[Docket No. 99-SW-80-AD]

Airworthiness Directives; Bell Helicopter Textron Canada Model 206L, L-1, L-3 and L-4 Helicopters

ACTION: Supplemental notice of proposed rulemaking; reopening of comment period.

Figure 1

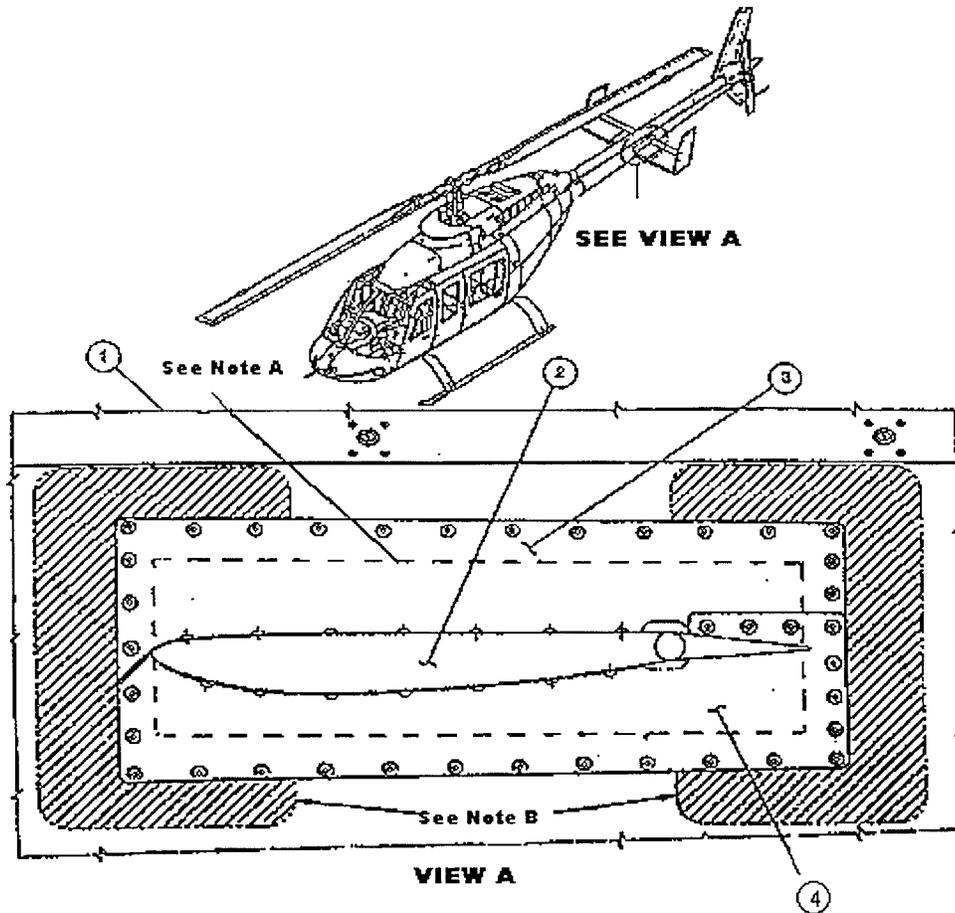
Both commenters state that the proposed compliance time for modifying the tailboom within 300 hours TIS should be increased to 600 hours TIS or no later than December 31, 2000, whichever occurs first, to coincide with the compliance times in the applicable ASB. The commenters state that changing the compliance time would give the manufacturer time to deliver the required secondary parts to modify the tailboom and eliminate considerable replanning by operators of their maintenance programs. Also, the commenters state that the repetitive inspections required before modifying the tailboom will ensure safety until the modification is done.

One commenter states that the compliance time should change because a redesigned tailboom, part number (P/N) 206-033-004-181, is now manufactured with the required skin doubler hot-bonded in place. The FAA agrees and will add a statement in the proposal that installing an airworthy, redesigned tailboom, P/N 206-033-004-181, is terminating action for the requirements of the AD.

Another commenter states that the AD should inform operators that modifying the tailboom in accordance with earlier versions of the referenced ASB is acceptable (the proposal referenced Revision D of BHTC ASB 206L-99-115). The FAA agrees because changes to the original ASB are minor and do not change or compromise the previous engineering approval. Therefore, the proposal will include a note stating that modifying the tailboom in accordance with earlier versions of the referenced ASB is acceptable.

The FAA agrees with the comments, however, the December 31, 2000, date has passed. Further, since publication of the NPRM, the manufacturer has revised their ASB and changed the compliance time to March 31, 2002. That date has also passed. Because of these delays, we have reevaluated the need for modifying the tailboom within 300 hours time-in-service (TIS). We now believe that a compliance time of 600 hours TIS is sufficient to meet our safety objectives.

(a) Before further flight and thereafter at intervals not to exceed 10 hours time-in-service (TIS) until accomplishing a one-time fluorescent-penetrant inspection (FPI) required by paragraph (c)(2) of this AD, visually inspect for a crack in the tailboom using a 10-power or higher magnifying glass in the shaded areas as depicted in Figure 1 of this AD:

(2) Perform a one-time FPI of the edges of the tailboom skins for any crack around the left and right horizontal stabilizer openings as shown in Figure 1 of this AD. Remove paint and primer to inspect the edges and exterior skin surface in the skin area at least 3/4 inch around the edges of the horizontal stabilizer openings as shown in Figure 1 of this AD.
